**NATIONAL INSTITUTE OF
OCCUPATIONAL SAFETY AND HEALTH**

ADVISORY BOARD ON RADIATION AND WORKER HEALTH

***REVIEW OF NIOSH/ORAUT PROCEDURES AND METHODS
USED FOR DOSE RECONSTRUCTION
(Supplement 1)***

**Contract No. 200-2004-03805
SCA-TR-TASK3-0001, Revision 1**

Figure 3.7-1. K-S and A-D Statistics for All Distributions Fitted to a Sample of 10,000 Products using Crystal Ball 2000 Batch Fit Procedure

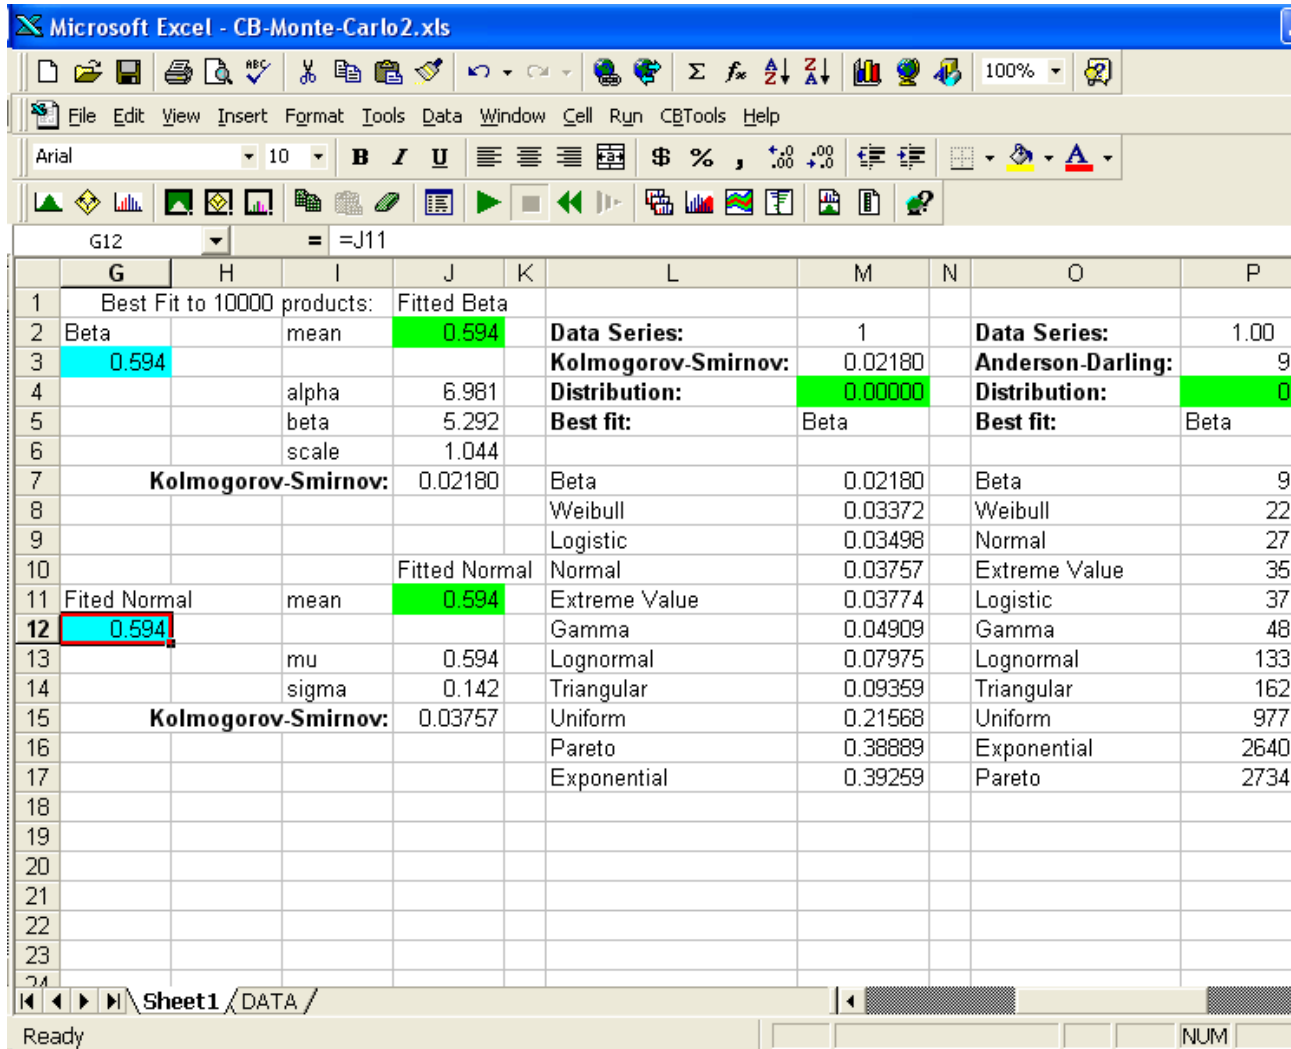
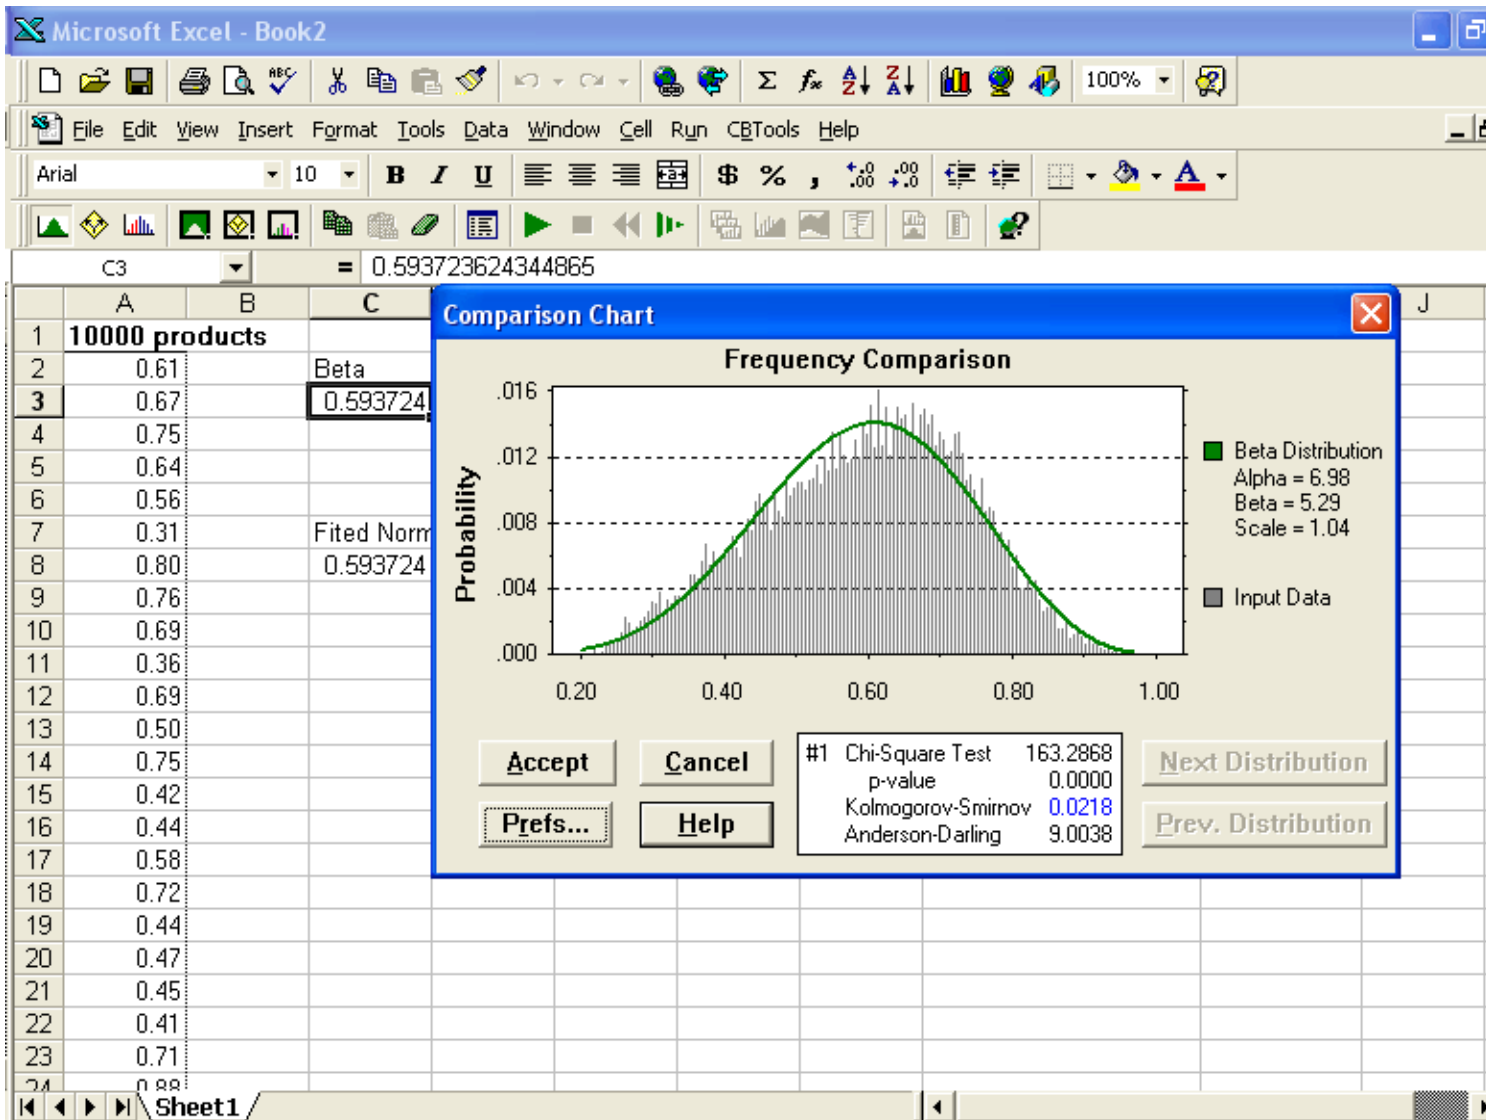
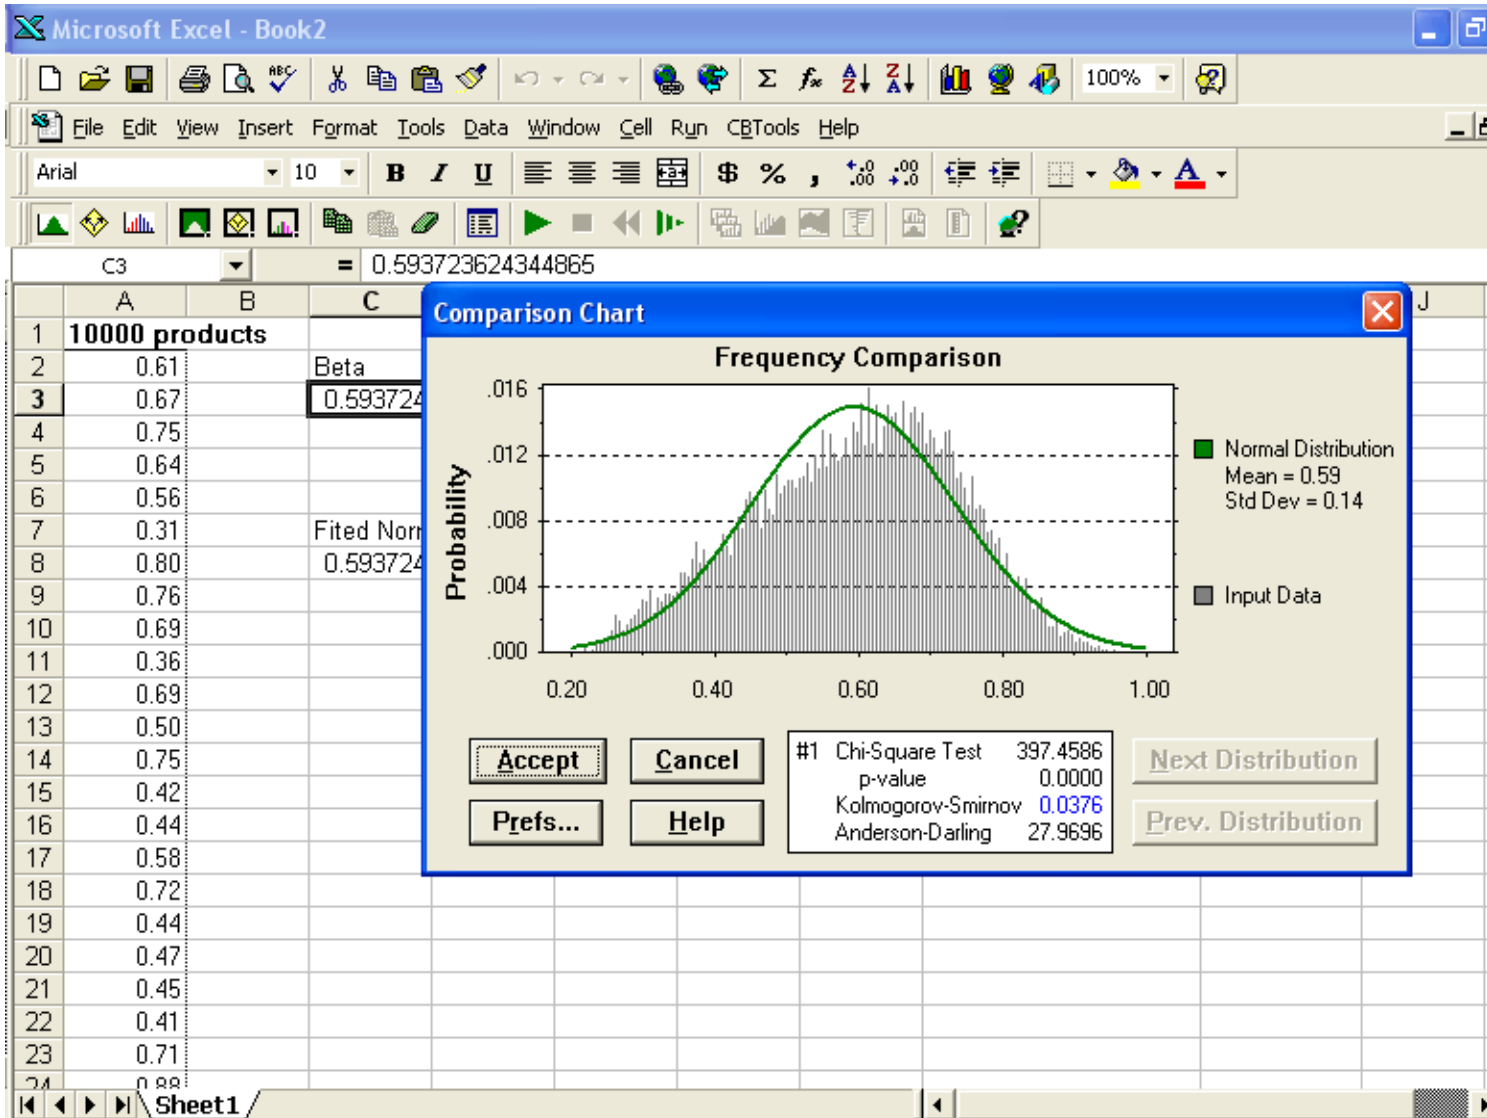
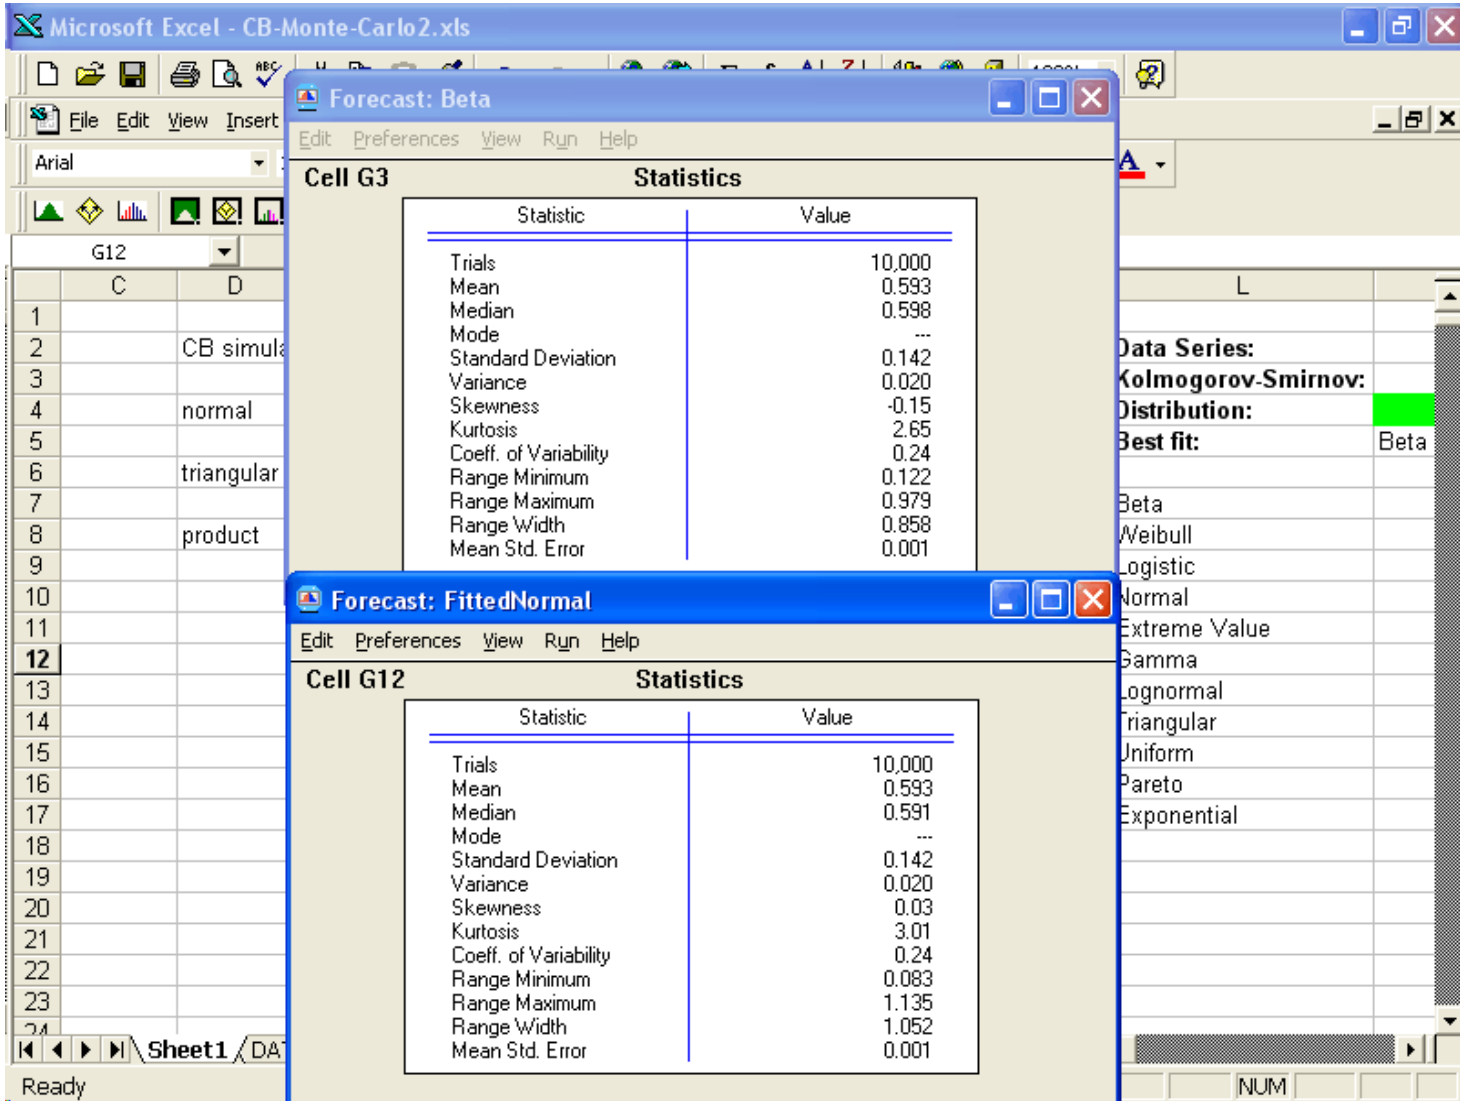
The results, shown in Figure 1, indicate that the beta distribution was found to be the best-fitting distribution under both criteria. In both cases, the second-best fit was obtained using a Weibull distribution. The normal distribution ranks third when using the A-D criterion, and fourth when using the K-S criterion.

Two samples of size 10,000 were simulated in Crystal Ball 2000 using the fitted beta and normal distribution with parameters stated above. Despite the clearly better fit of the beta distribution based on the statistical tests, there is little difference in the statistics obtained from the two simulated data sets, as shown in Figure 4. This confirms that the best-fitting normal distribution provides a good approximation for the distribution of the product organ doses in the example selected. If the normal distributions for the dosimeter reading have a larger standard deviation than the 0.10 value in this example, it is likely that a normal distribution will continue to provide a good approximation to the distribution of the product's organ doses.

Figure 3.10-1. Comparison of Lapel to Fixed Station Air Sampling
(Source: Caldwell et al. 1967)

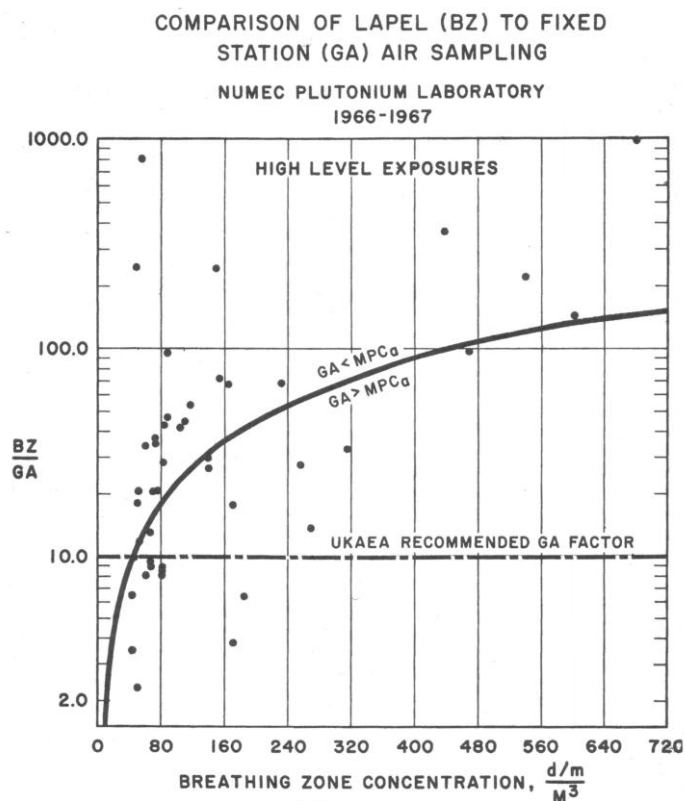
samples. Figure 3.10-1 below illustrates the strong tendency of GA samples to underestimate the air concentrations to which a worker is exposed. Important to note is that this discrepancy increases with air concentrations, and at the MPC level is, on average, about 70-fold too low.

Based on these data, a “rigorous” air monitoring program would require a comprehensive **breathing zone** air sampling program for individual workers and facility processes that is best defined by periodic low-volume **lapel** air sampling that extends over the total (or a large fraction) of an 8-hour workday. When BZ air sampling is not performed or not adequately performed in the workplace and general area air sampling is used as the basis of the air monitoring program, established monitoring guidelines may not have been adequately met.
